AMENDMENT OF SOLICITATION/MODIFICATION OF CONTRACT				1. CONTRACT ID CODE	PAGE OF PAGES	
				J	1	2
2. AMENDMENT/MODIFICATION NO. 0001		3. EFFECTIVE DATE 18-Jan-2006	4. REQUISITION/PURCHASE REQ. NO.		5. PROJECT NO.(If applicable)

14. DESCRIPTION OF AMENDMENT/MODIFICATION (Organized by UCF section headings, including solicitation/contract subject matter where feasible.) The above numbered solicitation for New Orleans To Venice Hurricane Protection Project, Buras Levee District, West Bank River Levee, Emergency Levee Repairs, Contract P17 - B/L Sta. 906+00 to B/L Sta. 1003+00, Plaquemines Parish, LA, is amended as shown on the attached page. PROPOSAL DUE DATE: THE PROPOSAL DUE DATE OF 26 JANUARY 2006, 10:00AM LOCAL TIME, NEW ORLEANS, LA, REMAINS UNCHANGED. Except as provided herein, all terms and conditions of the document referenced in Item 9A or 10A, as heretofore changed, remains unchanged and in full force and effect.						
15A. NAME AND TITLE OF SIGNER (Type or print)			16A. NAME AND TITLE OF CONTRACTING OFFICER (Type or print)			
			TEL:		EMAIL:	
15B. CONTRACTOR/OFFEROR		15C. DATE SIGNED	16B. UNITED STATES OF AMERICA		16C. DATE SIGNED

NEW ORLEANS TO VENICE
 HURRICANE PROTECTIO

PLAN / PROFILE
 B/L STA. 910+00 TO B/L STA. 980+00
 PLAQUEMINES PARISH, LA

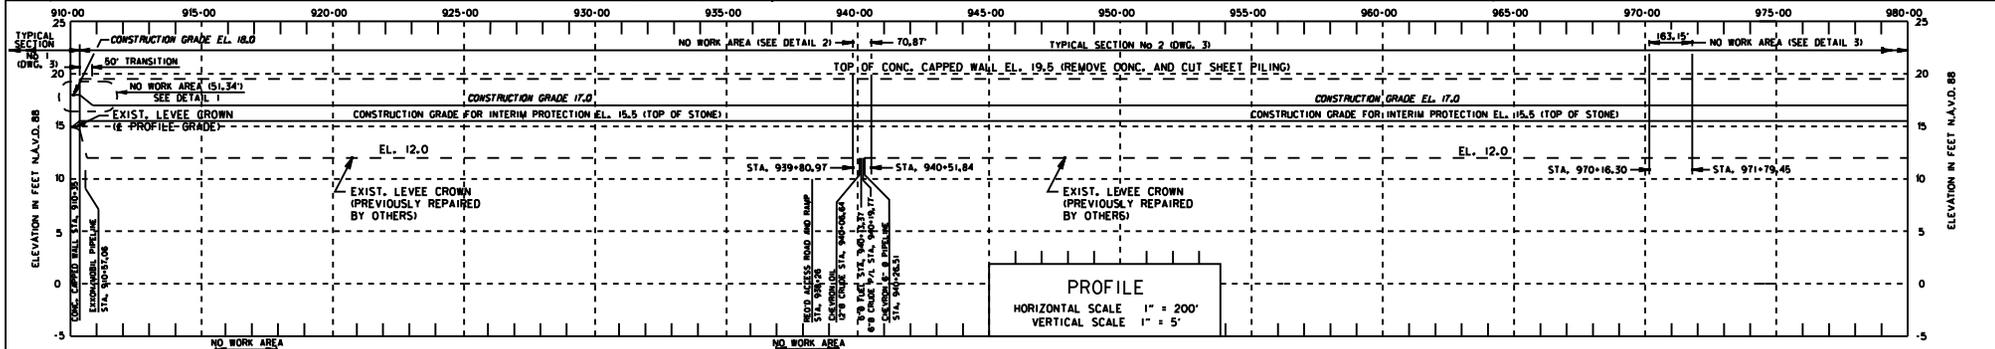
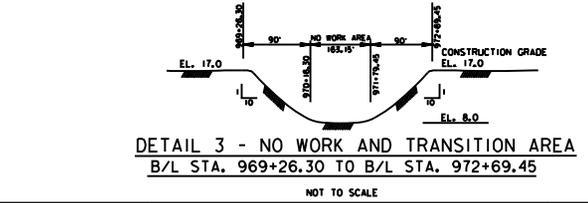
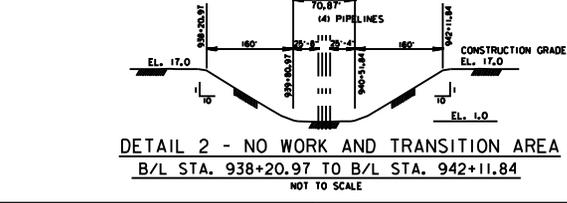
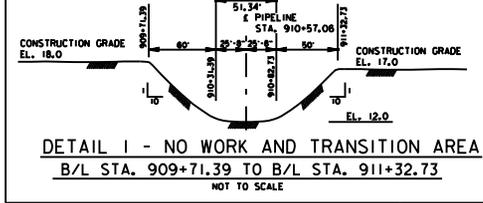
1. Delete Drawing 6 of 12 in its entirety and replace with the attached revised Drawing 6.
2. Delete Drawing 7 of 12 in its entirety and replace with the attached revised Drawing 7.
